Work Order ID 71014

Item Name: 205 Skidtube bent detail

DRAWING NO.	TITLE	REV.	DART AEROSPACE LTD	D.E.O. NO.	SHEET NO.	SCALE
D2580	205 SKIDTUBE ASSEMBLY	D	ENGINEERING ORDER	D2580-D-1	SHEET 1 OF 1	NTS

PURPOSE:
CHANGE ALL WELDED CROSSBOLT SPACERS TO SWAGED SPACERS

SECTION D-D & SECTION H-H ARE AMENDED AS FOLLOWS:

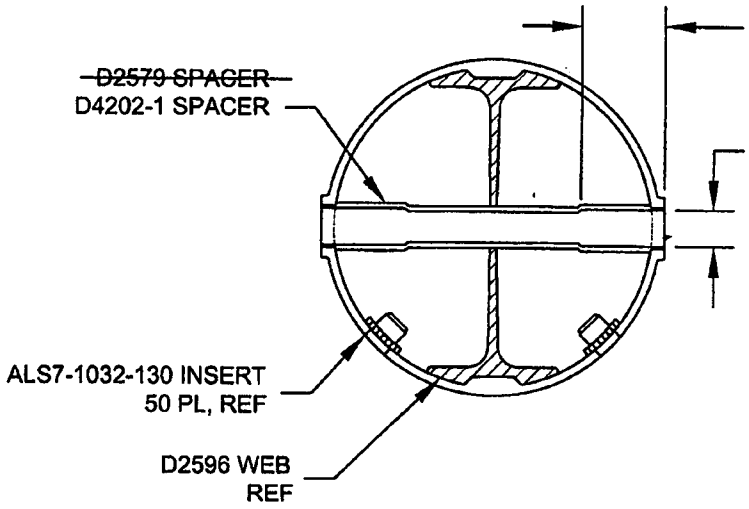
CHANGE:
PARTS LIST IS AMENDED AS FOLLOWS:

WAS

QTY -041	QTY -045	PART NUMBER	DESCRIPTION
20	24	D2579	CROSS BOLT SPACER

~~1. CHAMFER HOLE 0.050 X 45°~~
~~2. INSERT D2579 SPACER (20 PLACES)~~
~~3. WELD INTO PLACE AND GRIND FLUSH~~
~~4. C'BORE D2579 SPACER TO Ø0.437 X 1.00 DEEP~~

IS

20	24	D4202-1	SPACER

1. INSERT D4202-1 SPACER, 20 PL (-041) OR 24 PL (-045)
2. SWAGE TO Ø0.437 X 1.00 DEEP PER QSI 002
3. TRIM / GRIND FLUSH PER QSI 002
